Addendum No. 1

*Farmers Alliance Mutual Insurance
1122 North Main Street
McPherson, Kansas 67460*

Architect's Project Number: 22.31

Addendum No. 1 (Articles 1.1 thru 1.14) 2 Pages + Attachments

CODE COMPLIANCE PLAN

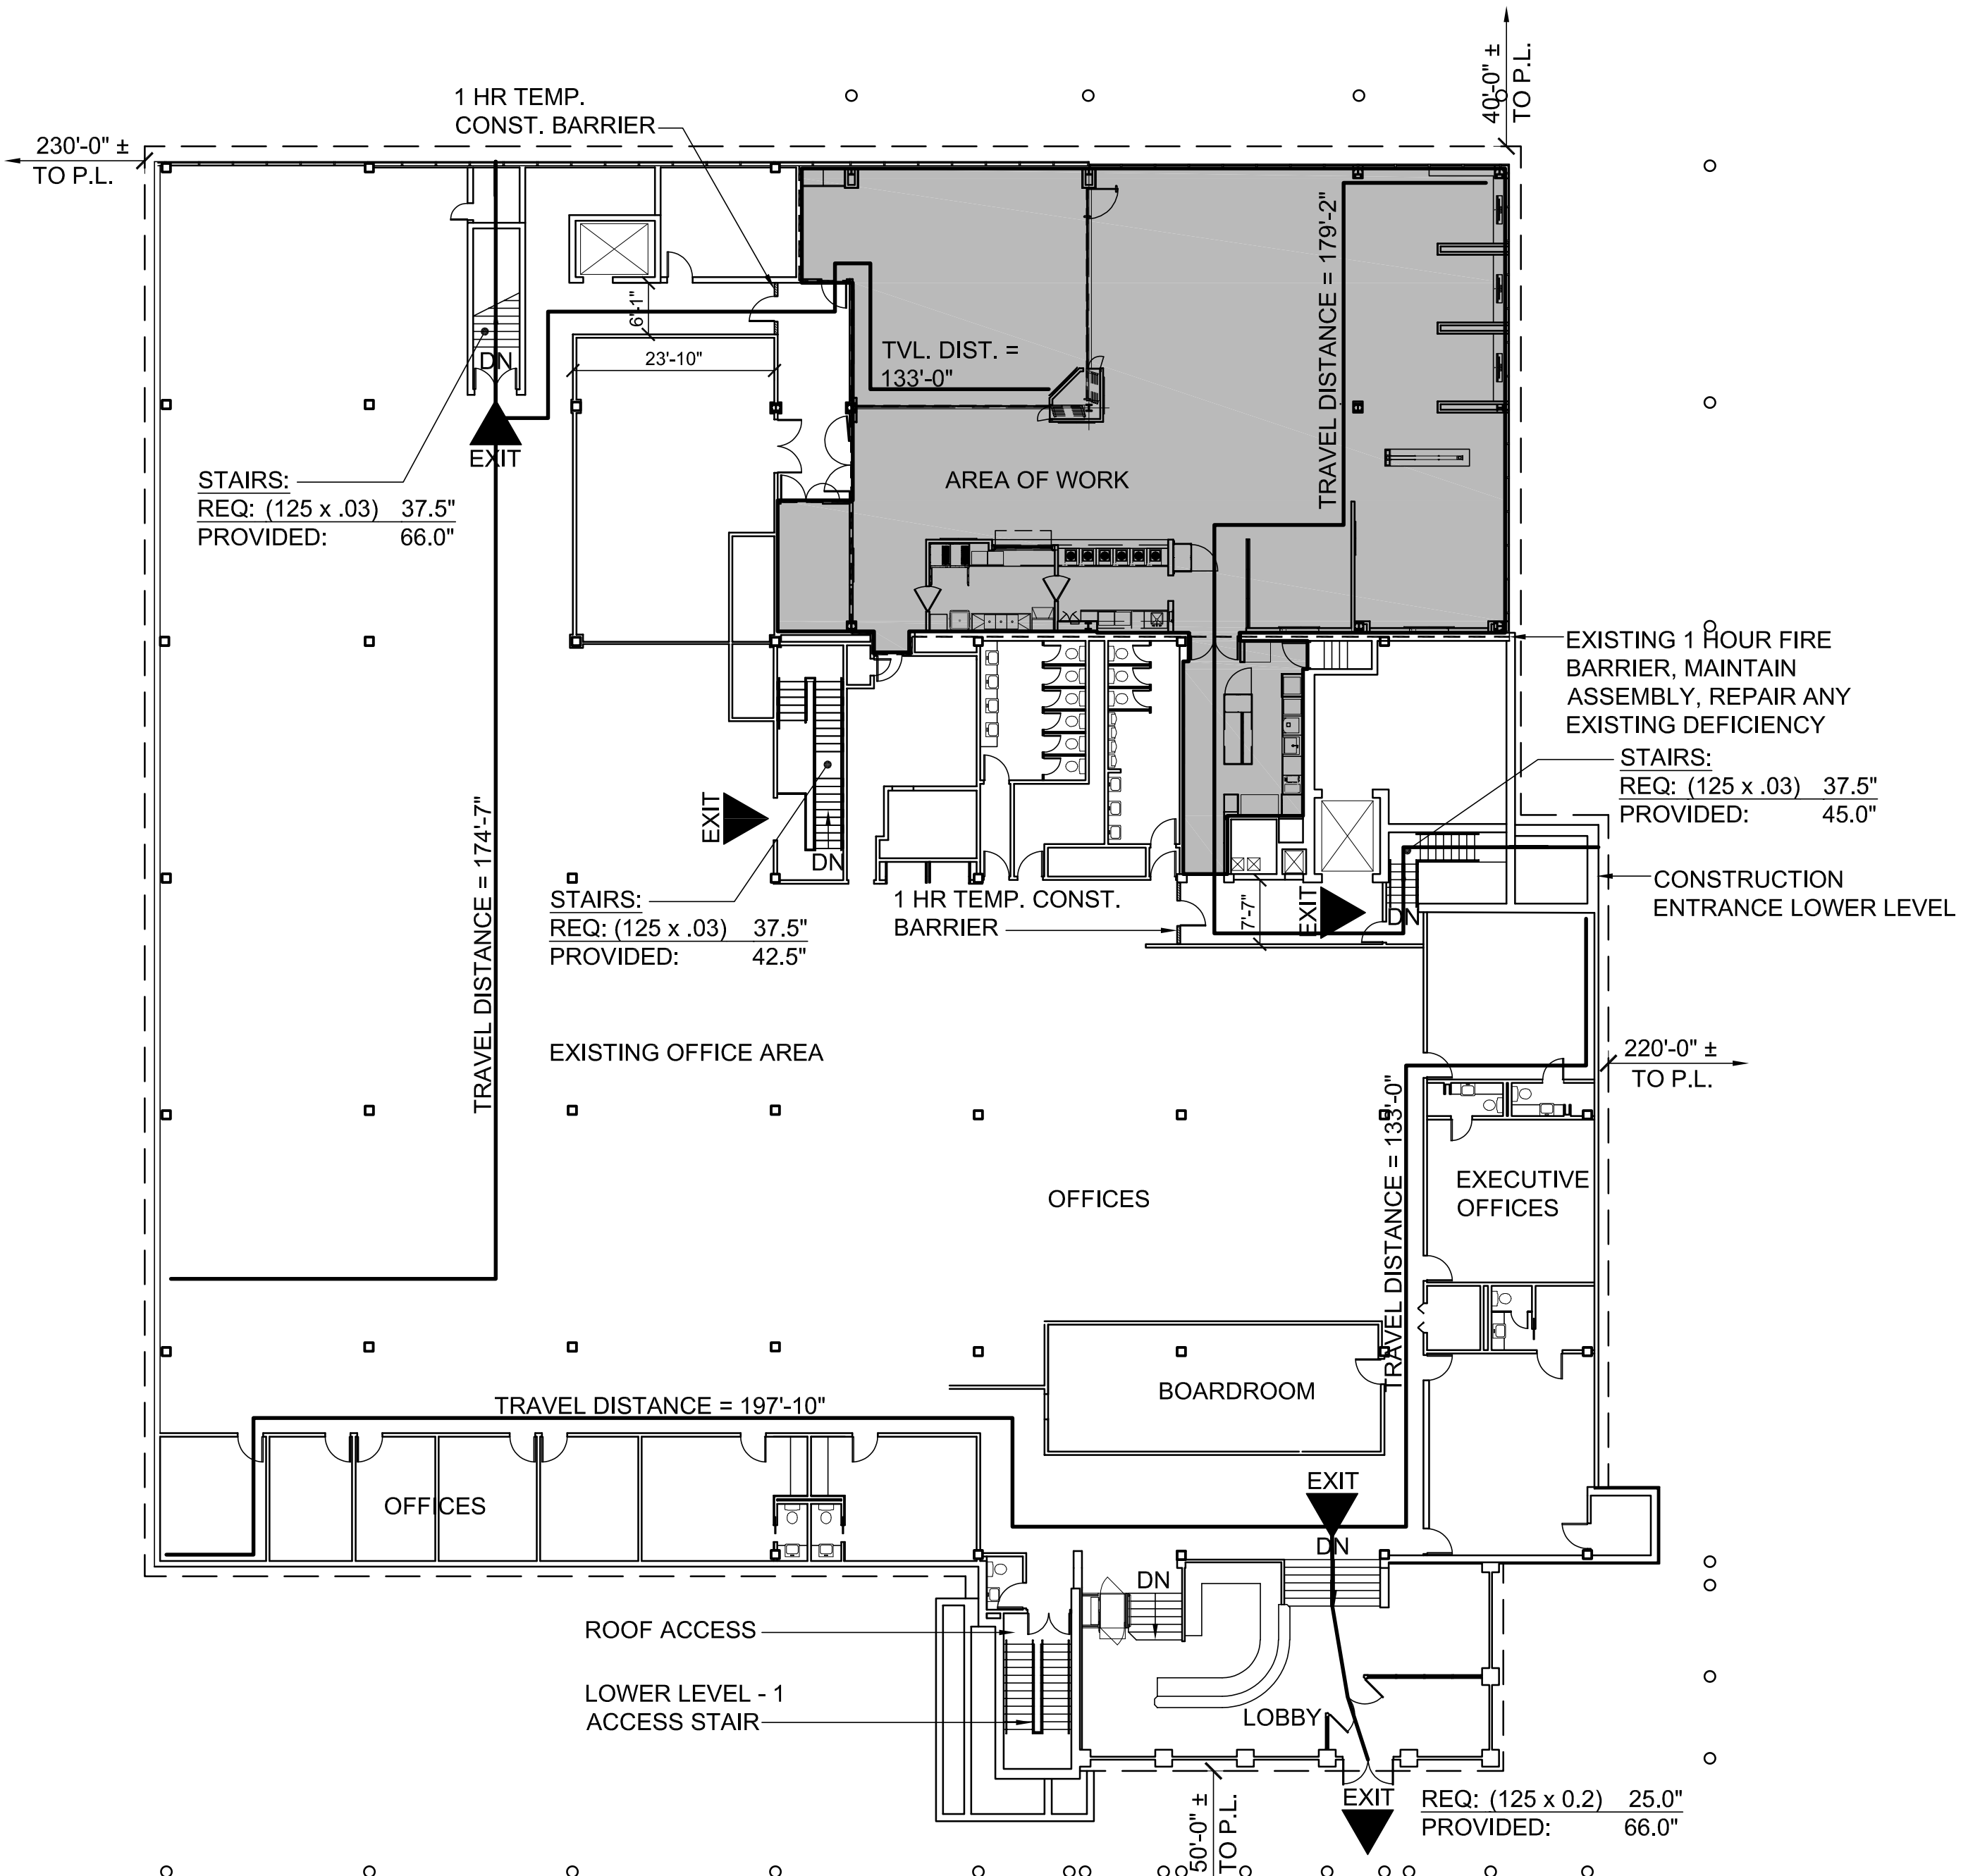
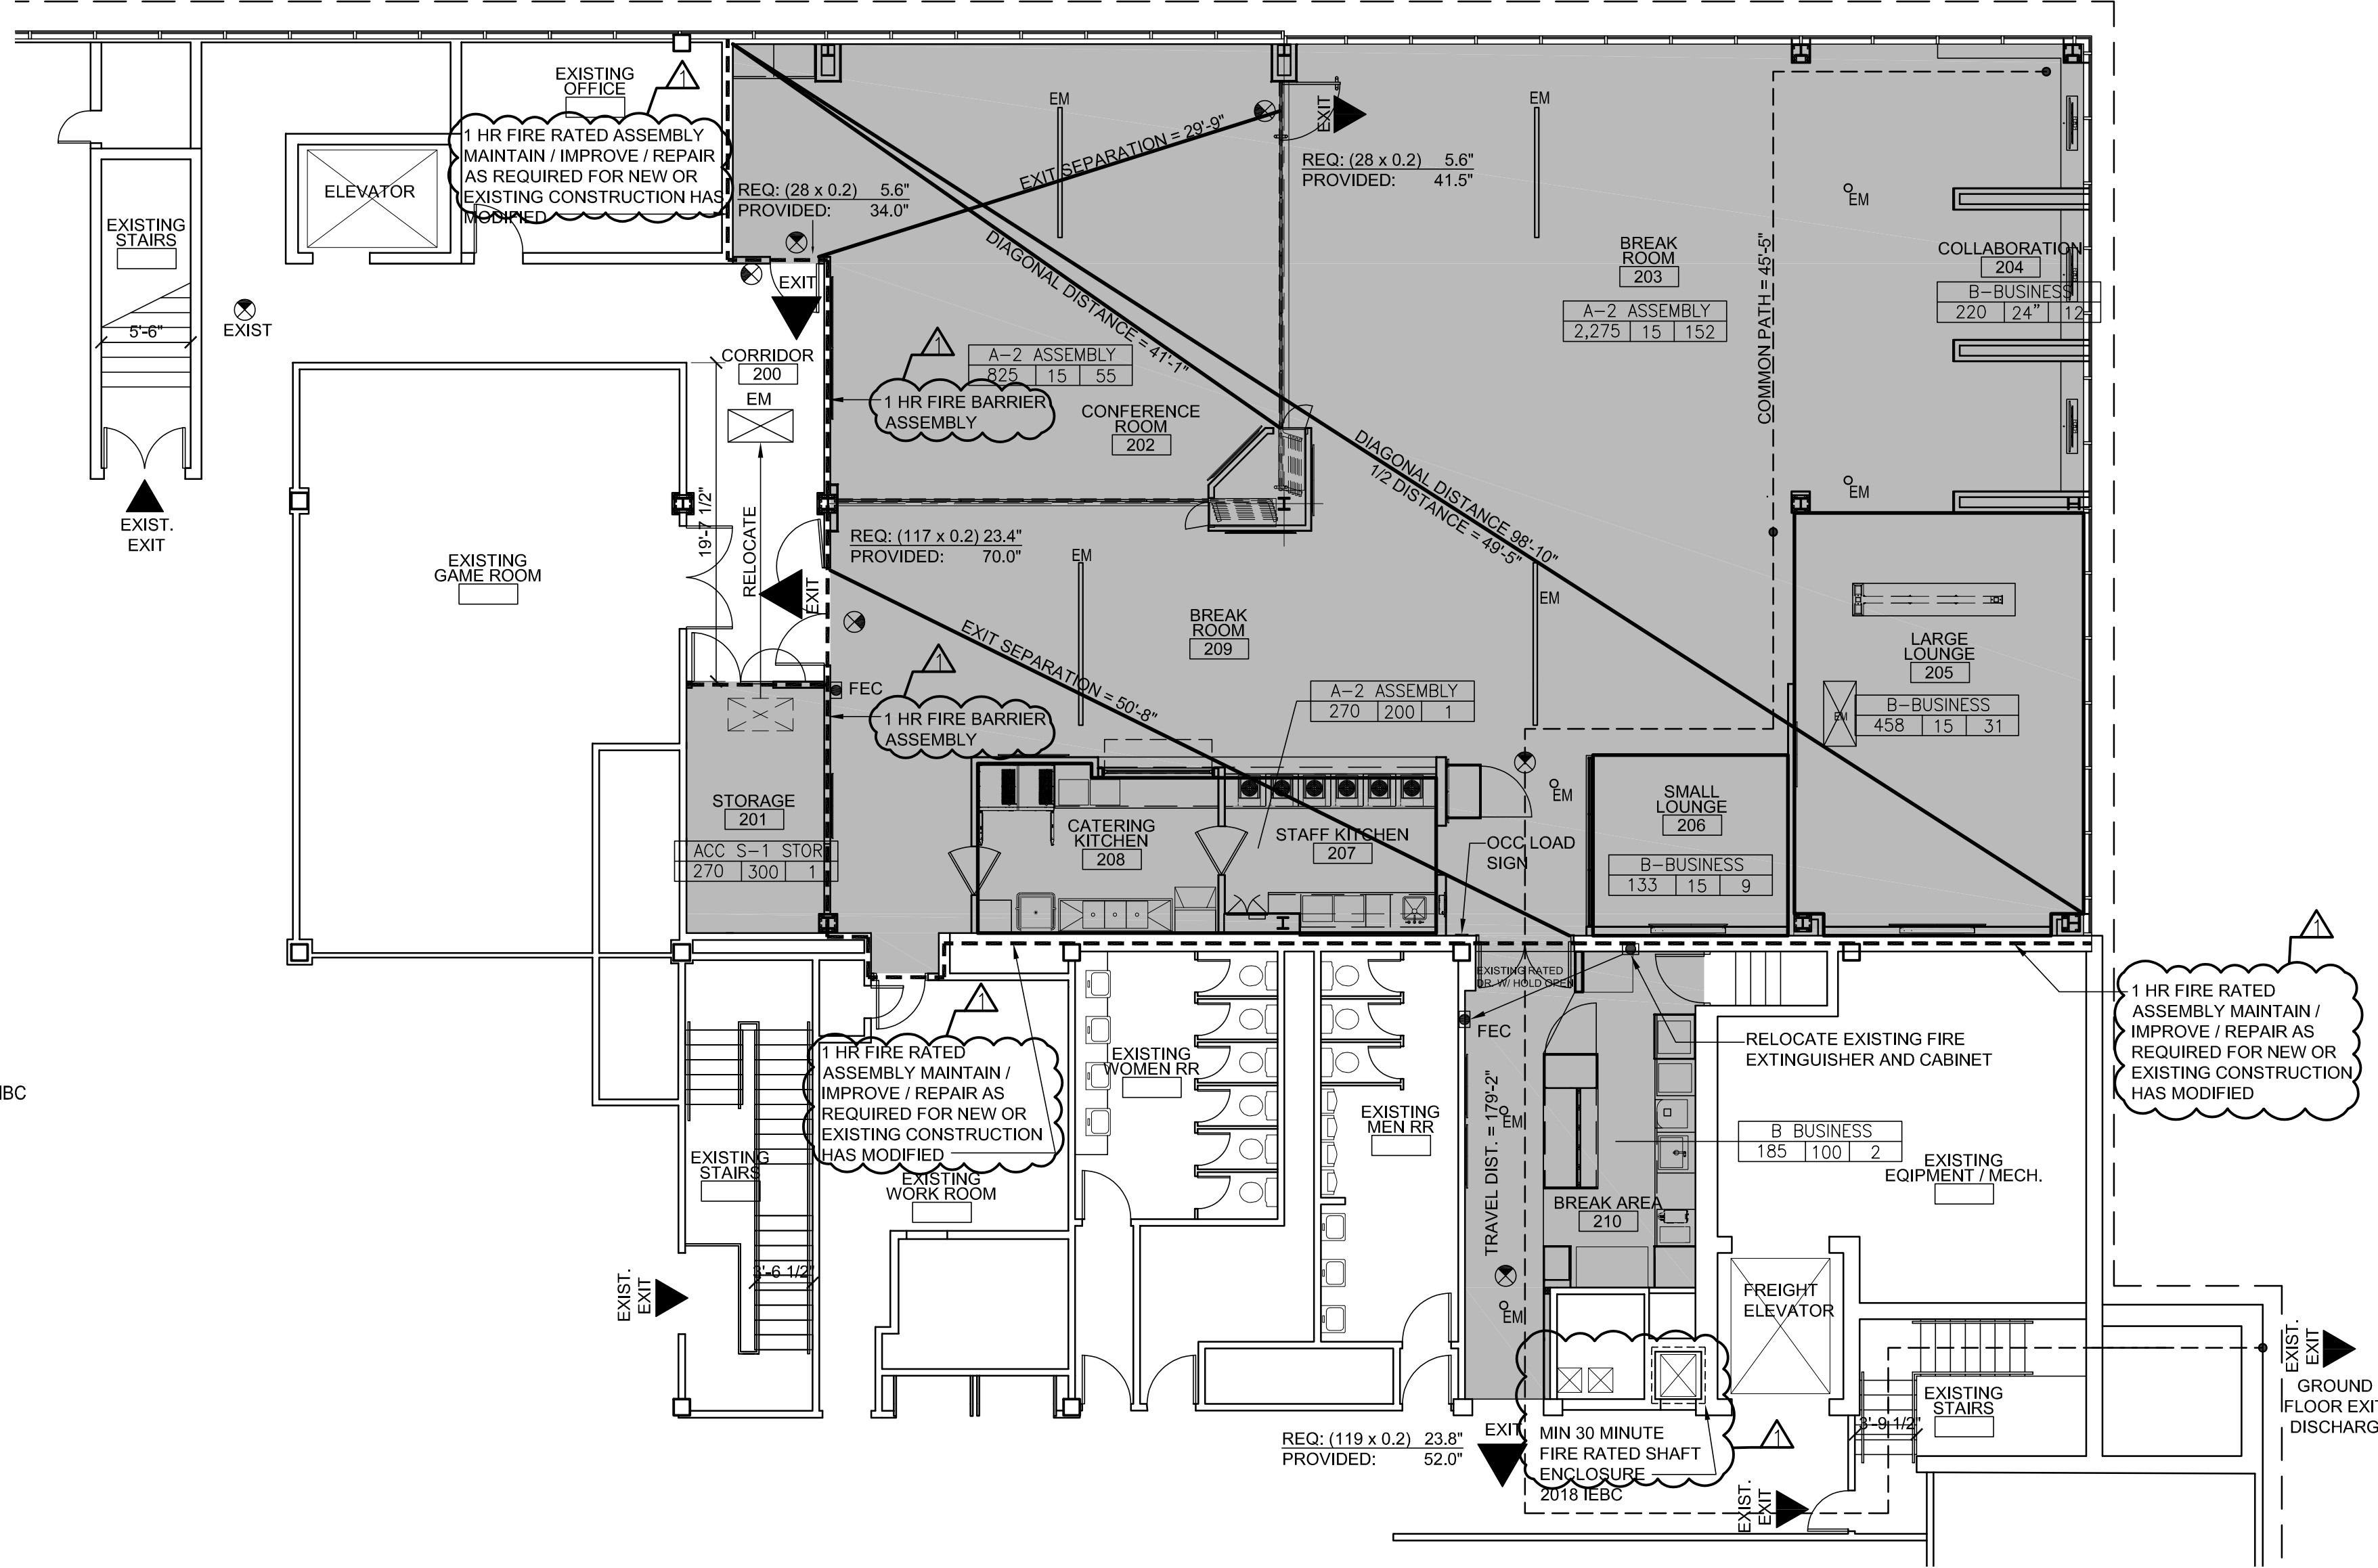
Article 1.6. Architectural: CC100 Code Compliance Plan (See Attached)

A. **Replace** with Sheet CC100 Code Compliance Plan.

Article 1.7. Architectural: CC101 Code Compliance Plan (See Attached)

A. **Replace** with Sheet CC101 Code Compliance Plan.

A4 FINISH FLOOR PLAN
SCALE: 3/16" = 1'-0"
0 2 4 8 FT

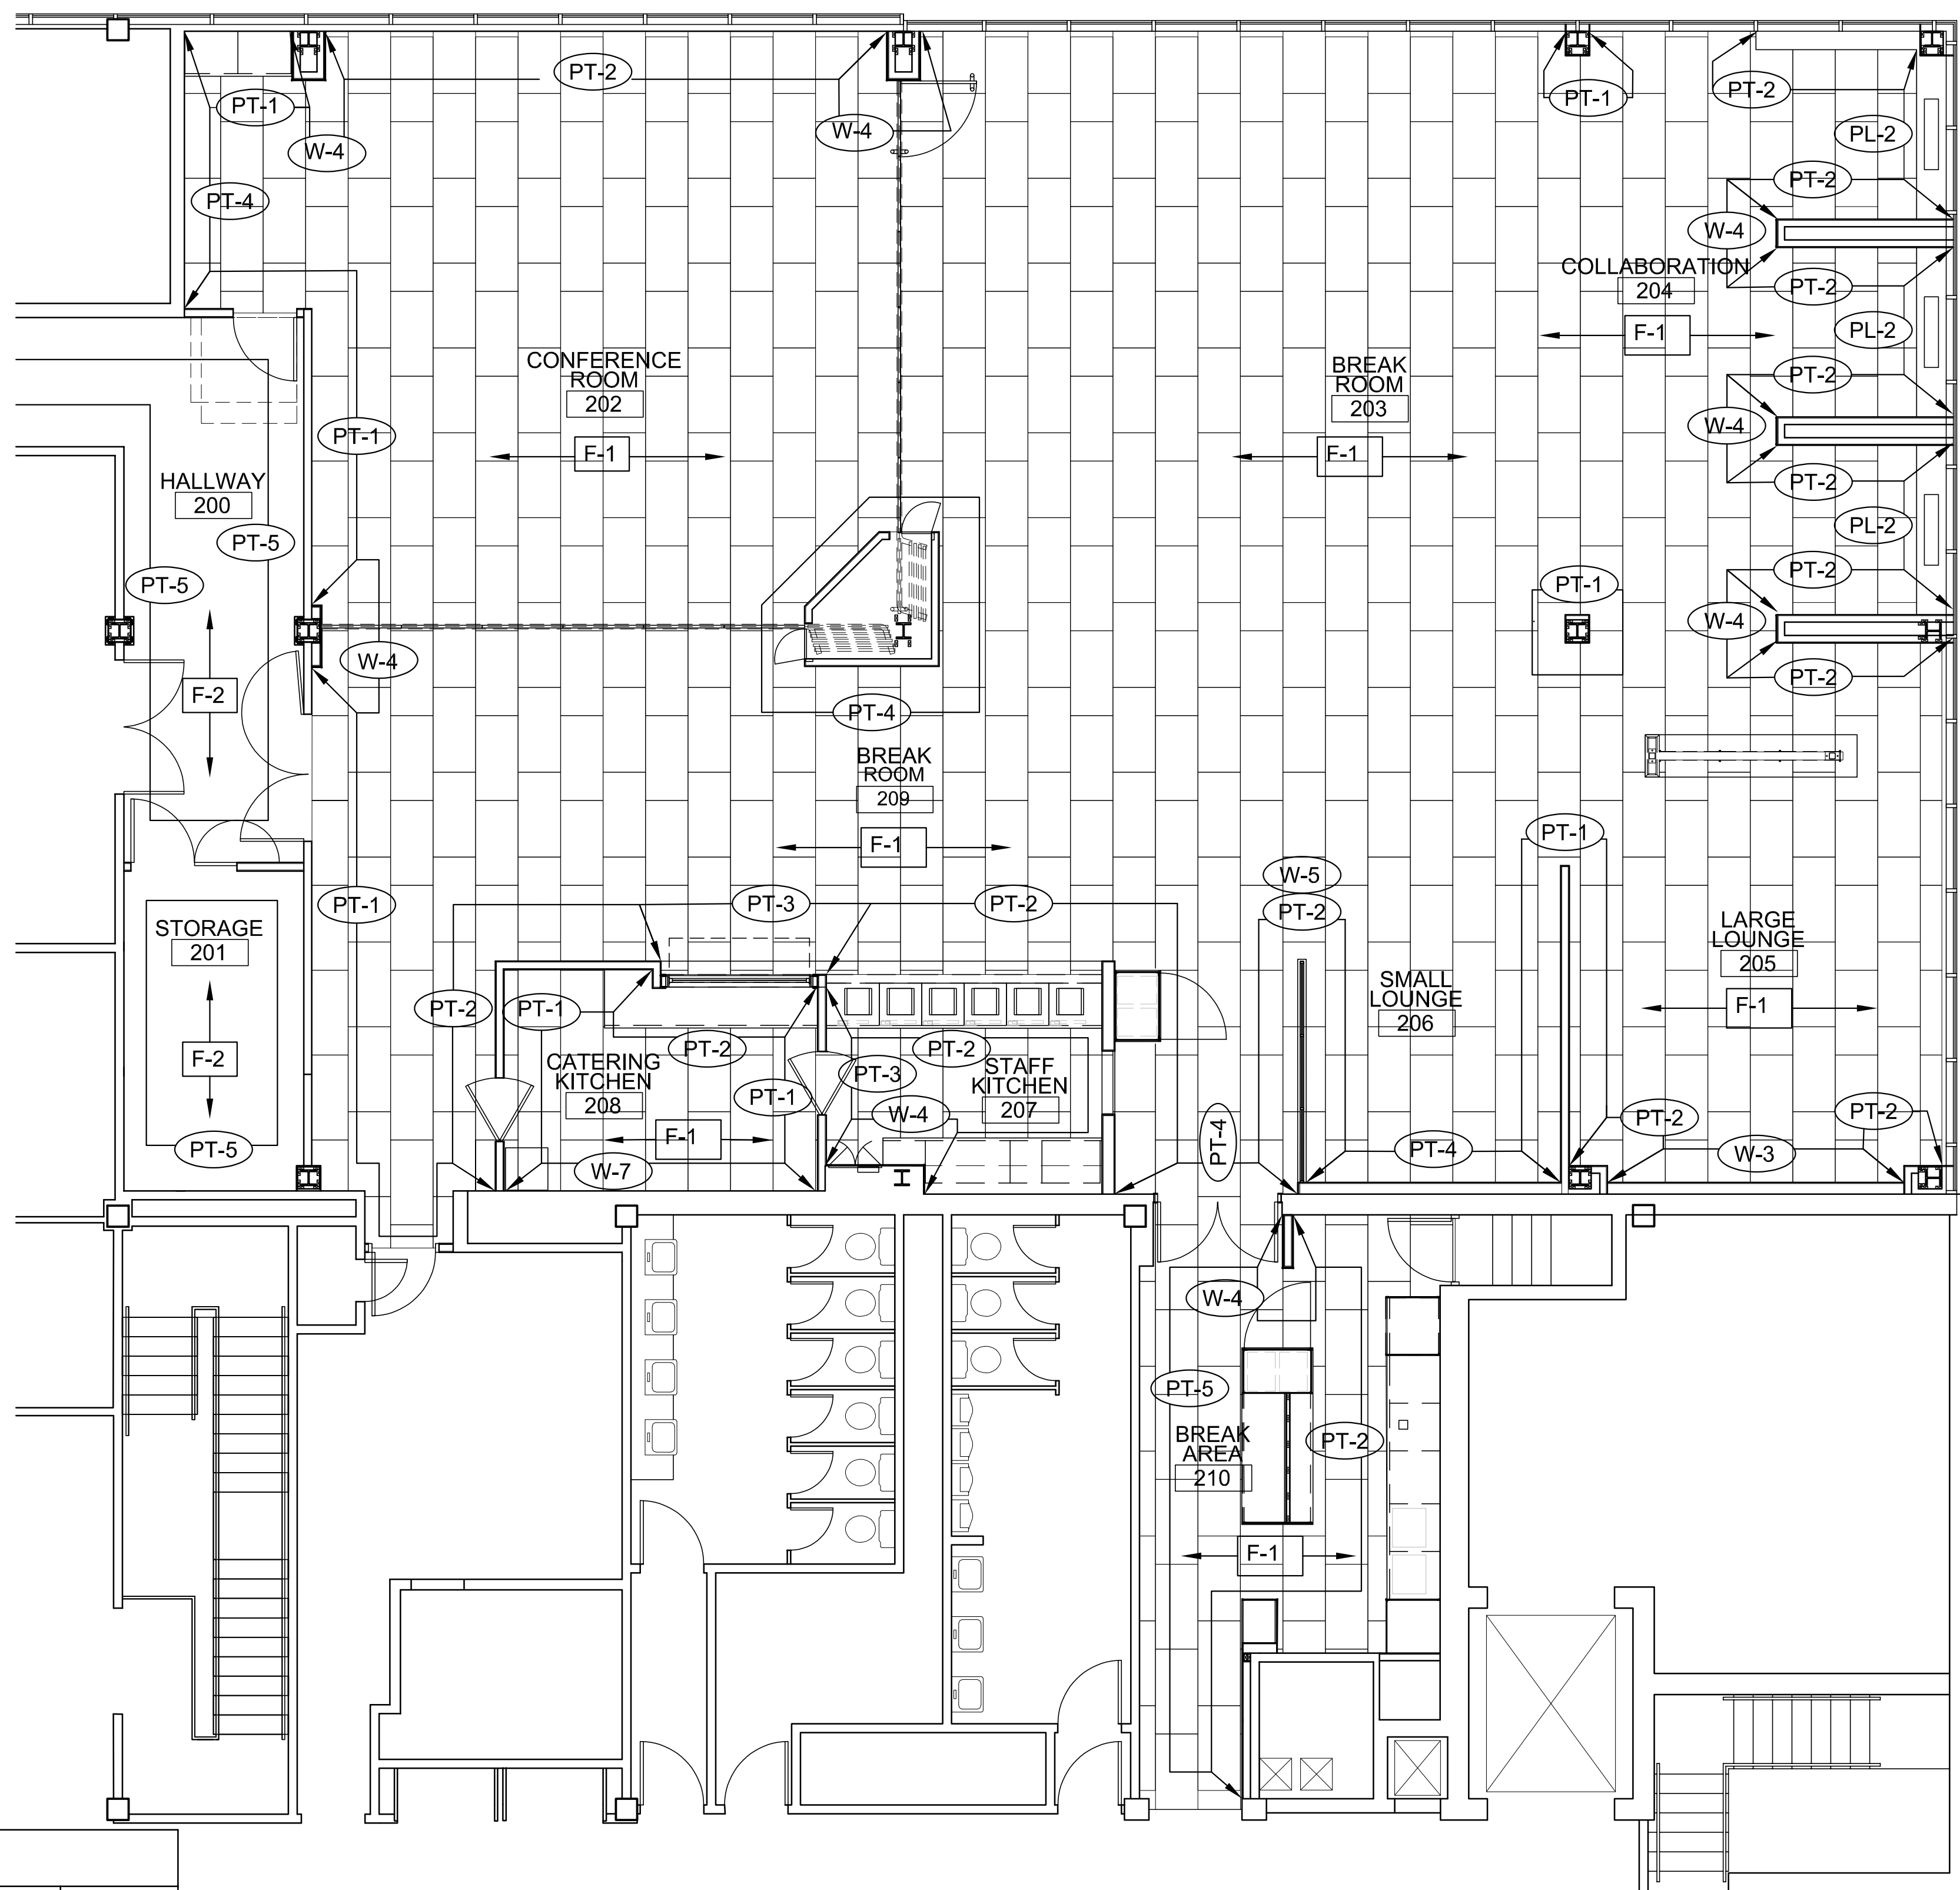
Article 1.9. Architectural: A010 Finish Schedule (See Attached)

A. **Add:** Finish Schedule – 207 Staff Kitchen – West Wall, Add W-1.
